Application for URBAN DESIGN COMMITTEE Review

RE: City of Richmond Department of Public Works - N. Hopkins Road Complex

Urban Design Committee DPW – N. Hopkins Road Complex Final Design Submittal March 19, 2015 Page 2 of 3

A101-3

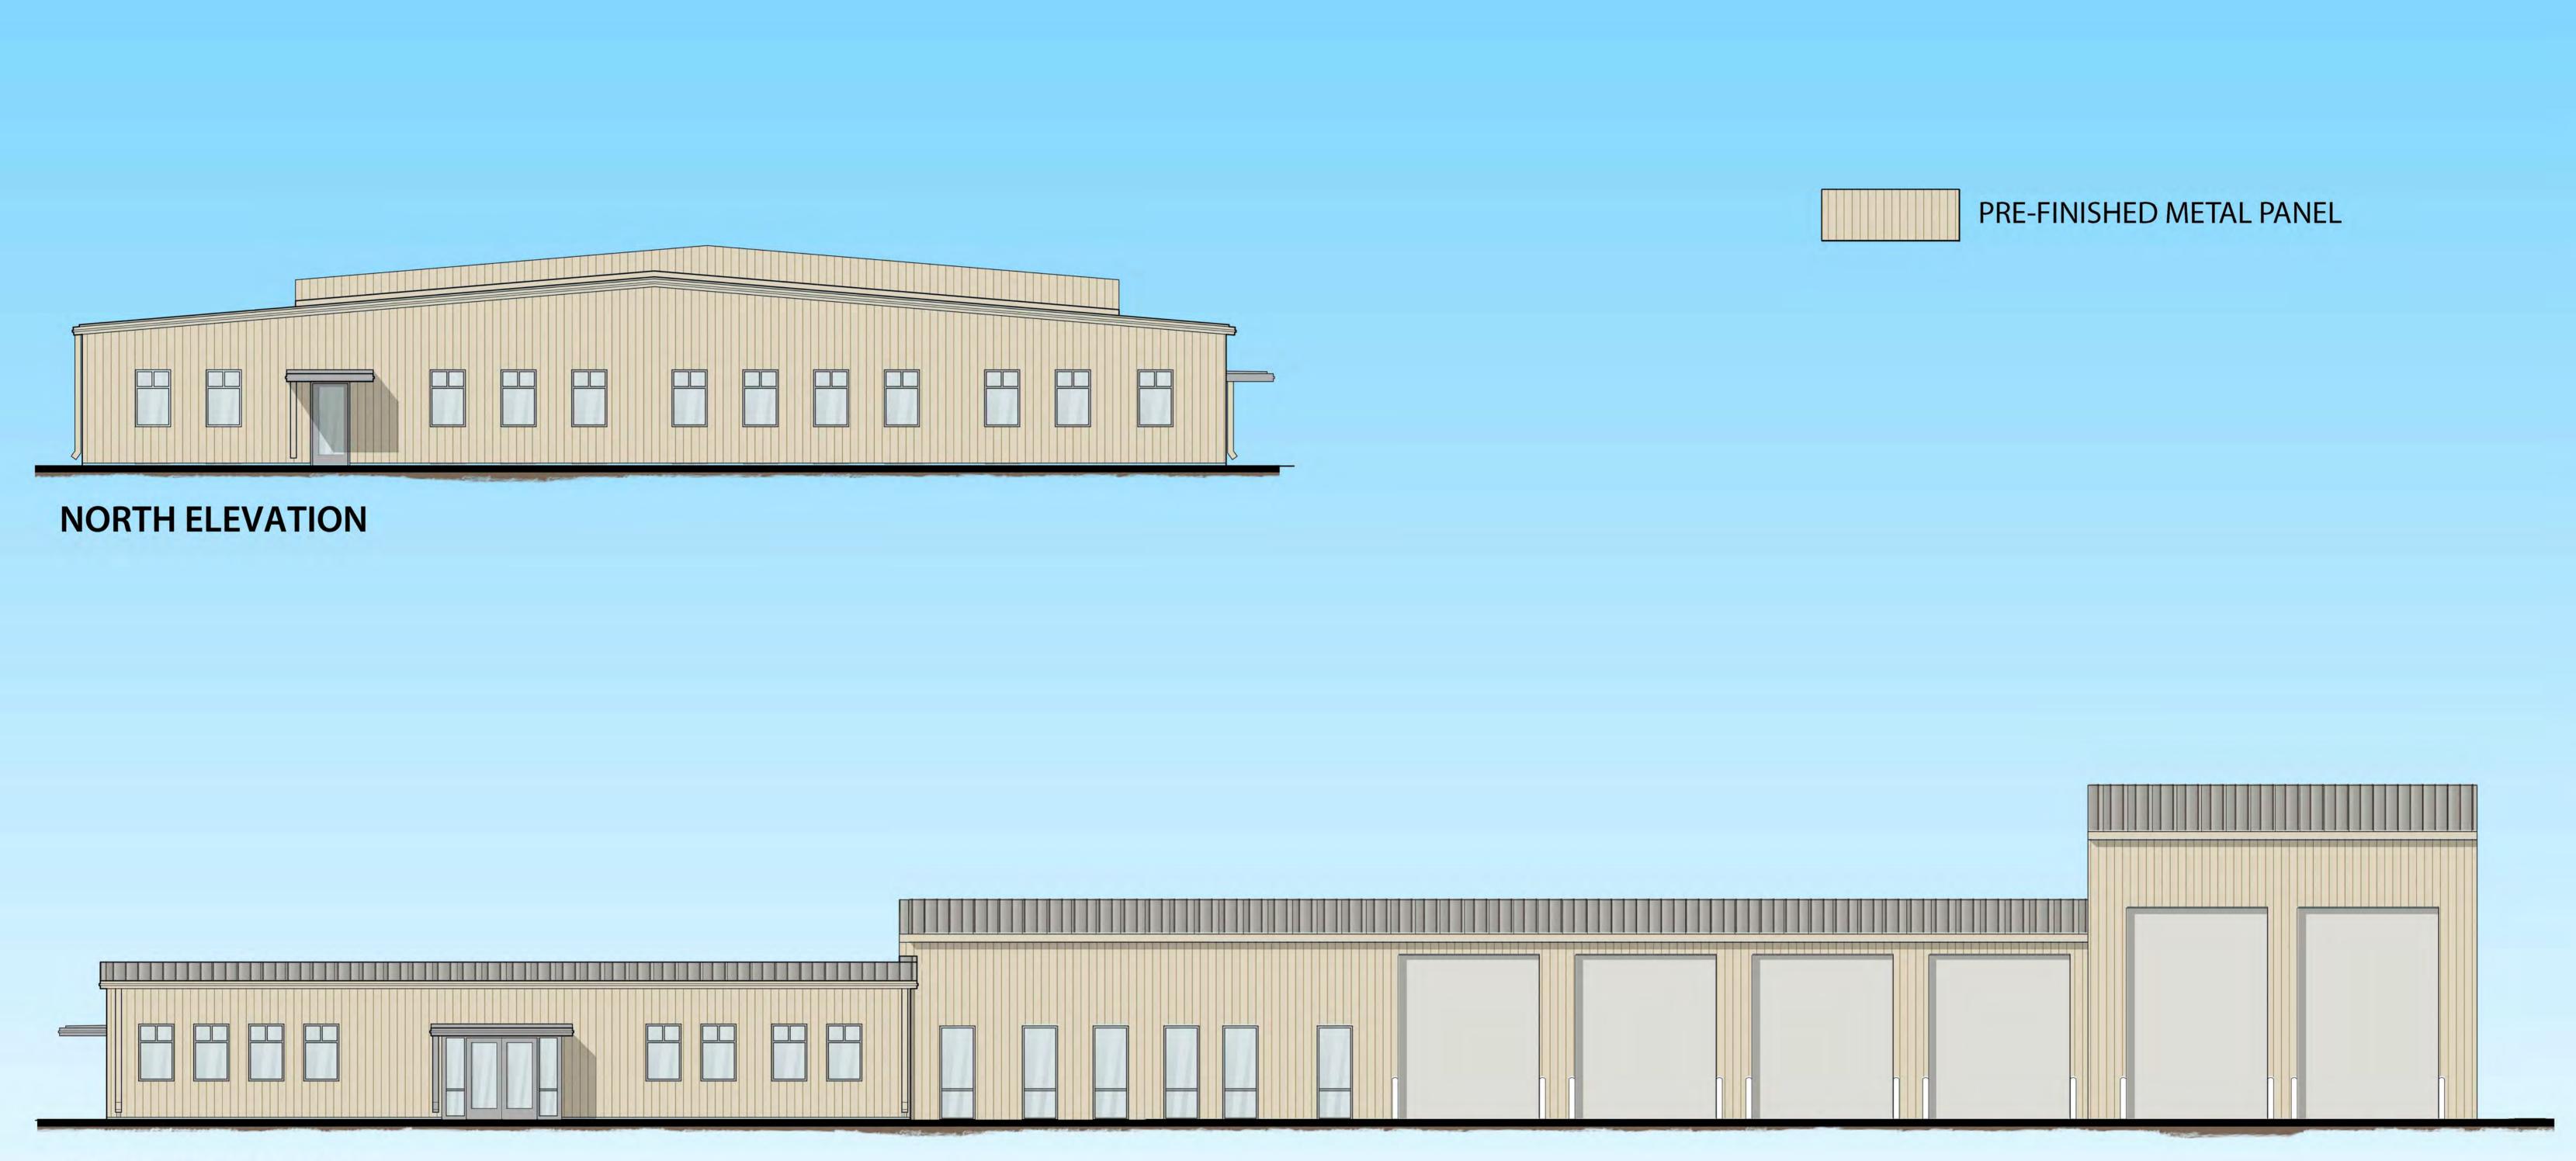
As part of the project design process, the Department of Public Works, in conjunction with the design team, performed a cost estimate of the conceptual design documents. The results of that estimate showed the project to be approximately \$1.5 million over the approved project budget. In order to align the budget and proposed features, minor architectural revisions were made. The Building 3 addition no longer includes splitface CMU. Instead, the building will be metal panel, matching the existing exterior conditions. Also, the direction of the roof slope on the addition has been changed from a single slope pitched away from the existing building to a dual slope roof. The roof on the Building 3 addition was modified to address structural concerns.

The revised exterior treatment of Building 4 has removed the splitface CMU block from the high-bay (eastern) portion of the building, but has been retained on the lower bay (western) portion facing Hopkins Road. Additionally, a canopy has been extended from the east face of the building to provide protection for bucket trucks.
